ADDENDUM NUMBER 1

PROJECT: GS #320-086 ARPA INFR. – DCF WATER CONS.
DEPARTMENT OF CORRECTIONS
GREENWOOD, MS
RFx # 3160005638

PROJECT #: 22074

ADDENDUM DATE: FEBRUARY 3, 2023

SHEET NUMBER
P001

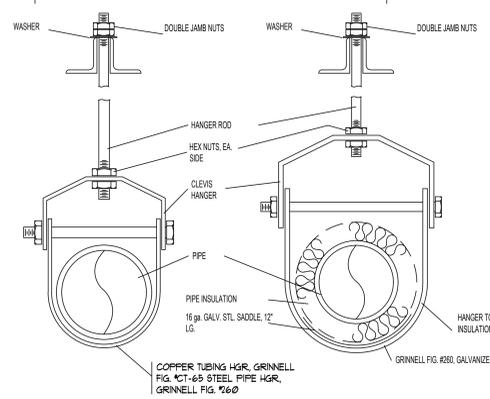
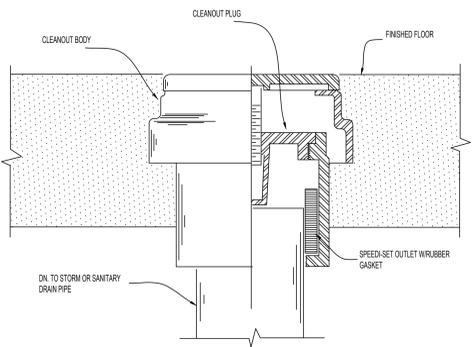
REFERENCE: Drawing Sheet P001 – Plumbing Legend, Schedule, and Details

ACTION: Revised Plumbing Schedule to include Water Closet WC-3, Lavatory L-3, Shower SH-1 and Notes 1, 2 and 3.

PLUMBING FIXTURE SCHEDULE							REMARKS	
SYMBOL	MANUFACTURER	MOD. NO.	MOUNTING	WSL	VNT	CW	HW	
WC-1	ACORN	1684-W-2-1.6-FVBO-FTA-ADA	FLOOR	4"	2"	1"	-	WATER CLOSET, STAINLESS STEEL SECURITY FIXTURE FLOOD-TROL W/ AUTO-RESET, ADA COMPLIANT W/ SLOAN ROYAL #952-1.6 HYDRAULIC FLUSH VALVE W/ HY-100-A METAL PUSH BUTTON PROVIDE JR SMITH 0874 INLET STACK FITTING PROVIDE EXPANSION ANCHORS FOR WALL/FLOOR
WC-2	ACORN	1685-W-2-1.6-FVBO-FTA	FLOOR	4"	2"	1"	-	WATER CLOSET, STAINLESS STEEL SECURITY FIXTURE FLOOD-TROL W/ AUTO-RESET W/ SLOAN ROYAL #952-1.6 HYDRAULIC FLUSH VALVE W/ HY-100-A METAL PUSH BUTTON PROVIDE JR SMITH 0874 INLET STACK FITTING PROVIDE EXPANSION ANCHORS FOR WALL/FLOOR
WC-3	SLOAN	950-1.6-MBFW	WALL	-	-	1"	-	1.6 GPF, HYDRAULIC, DIAPHRAGM FLUSH VALVE, ROUGH-BRASS FINISH REAR SPUD, W/ HY-100-A METAL PUSH BUTTON SEE NOTE # 1 BELOW
L-1	ACORN	1652FALRB-1-DMS-04-M	WALL	1 1/2"	2"	1/2"	1/2"	LAVATORY, 304 STAINLESS STEEL W/ RECTANGULAR BOWL SEAMLESS WELDED CONSTRUCTION ADA COMPLIANT, MOUNT SO THAT RIM IS 34" A.F.F. DECK-MOUNTED SPOUT, HOT & COLD METERING AIR CONTROL VALVE (LOCATE AIR CONTROL VALVE BEHIND TRAP ENCLOSURE UNDER LAVATORY) MCGUIRE #LFBV2165CC 1/4 TURN STOP VALVES, #8912 1 1/2" P-TRAP CONTRACTOR TO VERIFY EXISTING WATER AND WASTE ROUGH-IN LOCATIONS MODIFY EXISTING ROUGH-INS AS REQUIRED PROVIDE WALL ANCHORS AS REQUIRED FOR INSTALLATION ON 8" BLOCK WALL

L-2	ACORN	1652FALRB-1-DMS-04-M	WALL	1 1/2"	2"	1/2"	1/2"	LAVATORY, 304 STAINLESS STEEL W/ RECTANGULAR BOWL SEAMLESS WELDED CONSTRUCTION DECK-MOUNTED SPOUT, HOT & COLD METERING AIR CONTROL VALVE (LOCATE AIR CONTROL VALVE BEHIND TRAP ENCLOSURE UNDER LAVATORY) MCGUIRE #LFBV2165CC 1/4 TURN STOP VALVES, #8912 1 1/2" P-TRAP CONTRACTOR TO VERIFY EXISTING WATER AND WASTE ROUGH-IN LOCATIONS MODIFY EXISTING ROUGH-INS AS REQUIRED PROVIDE WALL ANCHORS AS REQUIRED FOR INSTALLATION ON 8" BLOCK WALL
L-3	ACORN	3383-M	WALL	-	-	1/2"	1/2"	HOT & COLD AIR-CONTROL VALVE ASSEMBLY MANIFOLD W/ 2 PUSH BUTTONS CAPABLE OF SERVING ONE LAVATORY. PROVIDE BRAIDED FLEXIBLE CONNECTIONS FROM WATER SUPPLY TO VALVE ASSEMBLY SEE NOTE # 2 BELOW
SH-1	ACORN	3382-M	WALL	-	-	-	1/2"	SINGLE-TEMP, AIR-CONTROL VALVE ASSEMBLY MANIFOLD W/ 1 PUSH BUTTON CAPABLE ONE SHOWER. PROVIDE BRAIDED FLEXIBLE CONNECTION FROM WATER SUPPLY TO VALVE ASSEMBLY SEE NOTE # 3 BELOW

FCO-1	ZURN	ZS1400-BZ1-8P-VL	FLOOR	4"	-	-	-	FLOOR CLEANOUT, CAST IRON BODY, BROZNE PLUG & STAINLESS STEEL COVER W/ VANDAL PROOF SCREWS

- NOTES:
- PROVIDE TEN (10) ADDITIONAL WC-3 FIXTURE TO BE GIVEN TO USERS AS ATTIC STOCK. NO INSTALLATION REQUIRED FOR ATTIC STOCK.
 - PROVIDE TEN (10) ADDITIONAL L-3 FIXTURES TO BE GIVEN TO USERS AS ATTIC STOCK. NO INSTALLATION REQUIRED FOR ATTIC STOCK.
 - PROVIDE ONE (1) ADDITIONAL SH-1 FIXTURE TO BE GIVEN TO USERS AS ATTIC STOCK. NO INSTALLATION REQUIRED FOR ATTIC STOCK.
